HISTORIC AND DESIGN REVIEW COMMISSION March 17, 2021

The applicant is requesting a Certificate of Appropriateness for approval to construct a new carport in the rear yard adjacent to the garage. The carport will be 20 x 21 and constructed of wood with a metal shed roof.

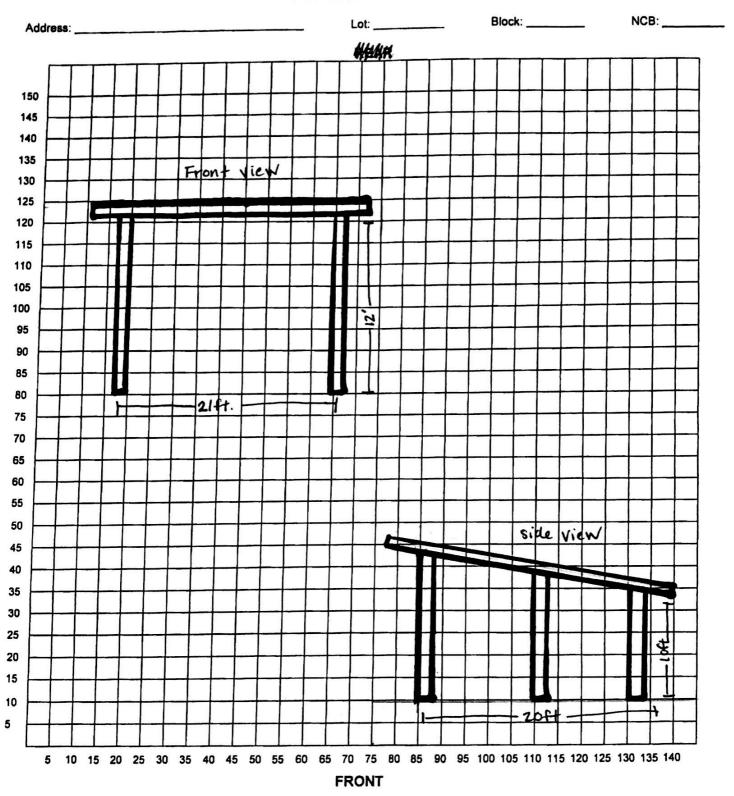
The materials for this project will consist of treated pine stained and cut to match the existing patio cover (see attached picture). The carport will consist of Six 4x4 posts, 2x8 beams, 2x6 rafters and 1x4 planks. The roof will be a standing seam metal.
